Stevie Ray's Comedy Cabaret

9801 Lyndale Avenue South, Bloomington, MN 55420

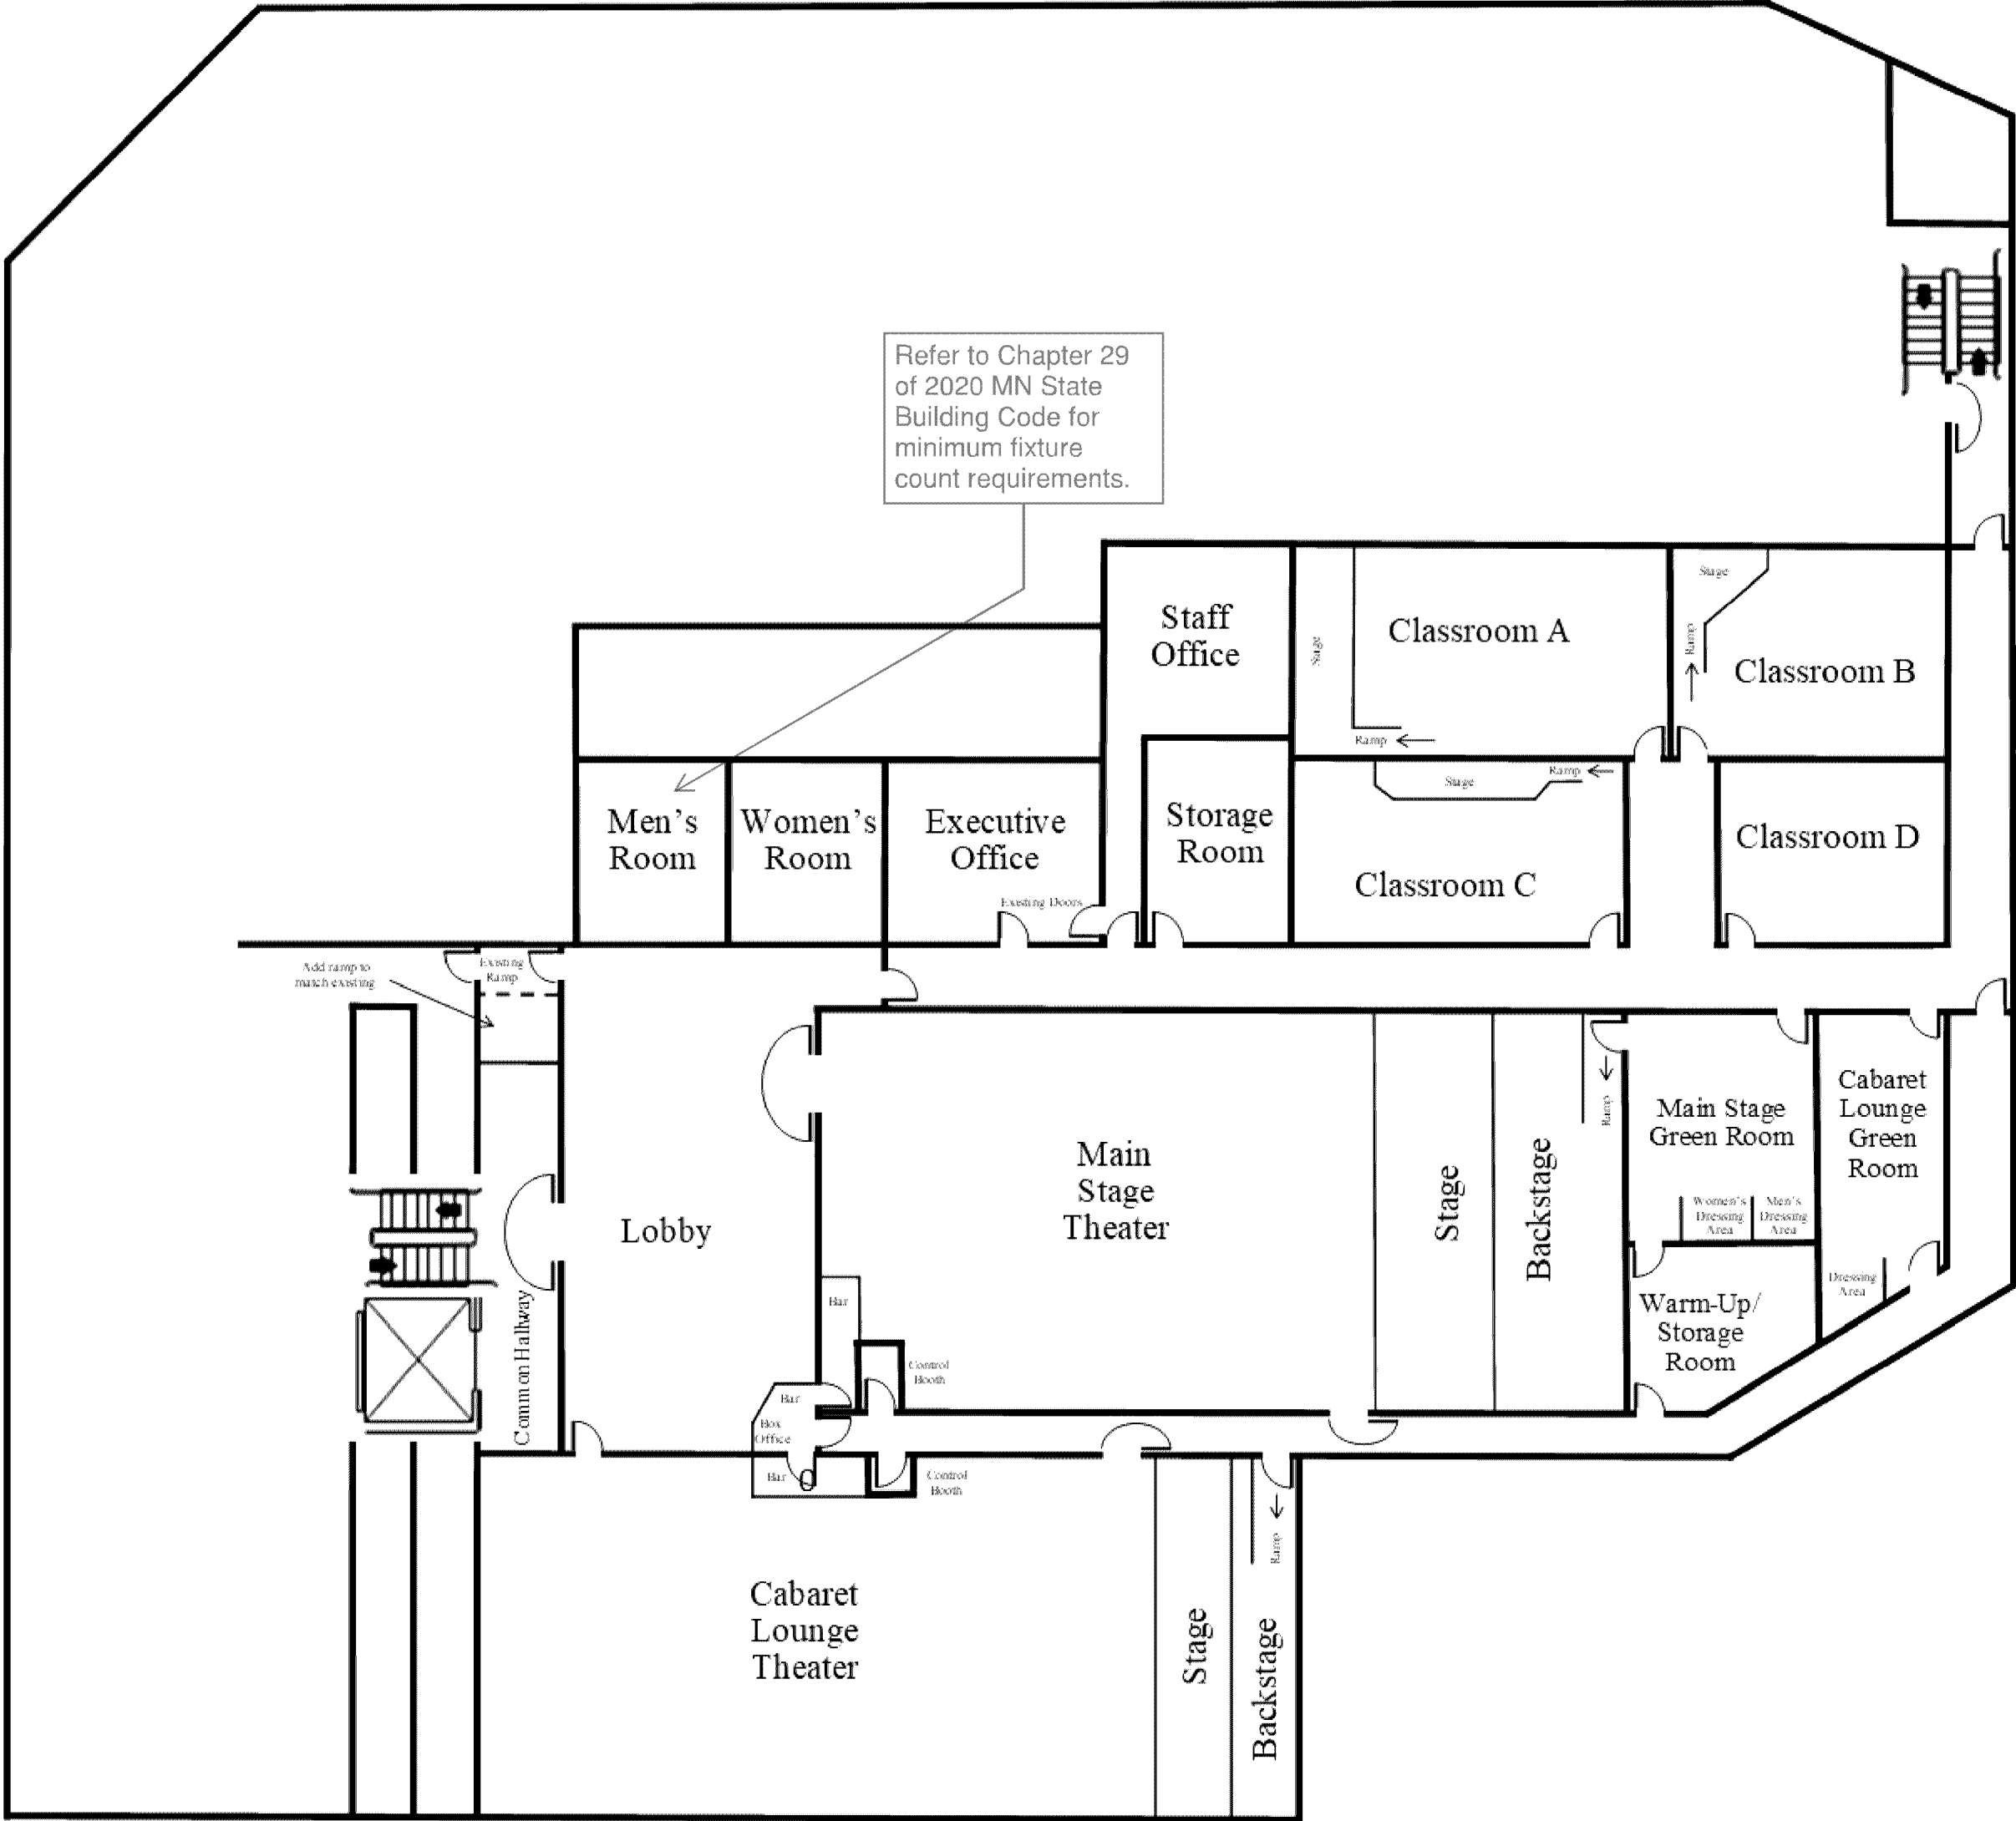
Emergency responder radio coverage meeting the requirements of appendix L in the 2015 MSFC shall be provided throughout the property and within the structures.

Fire alarm system may need to be upgrade for the assembly occupancy.

Entire space(s) must have fully Code
complying sprinkler protection.

Building/property shall be adequately signed for emergency response.

Building plans must be signed by a MN licensed architect.

Must meet 2020 MN
State Building Code

SAC review by MET council will be required.

Must meet 2020 MN
Accessibility Code.

Provide a detailed code analysis with the plans.
--
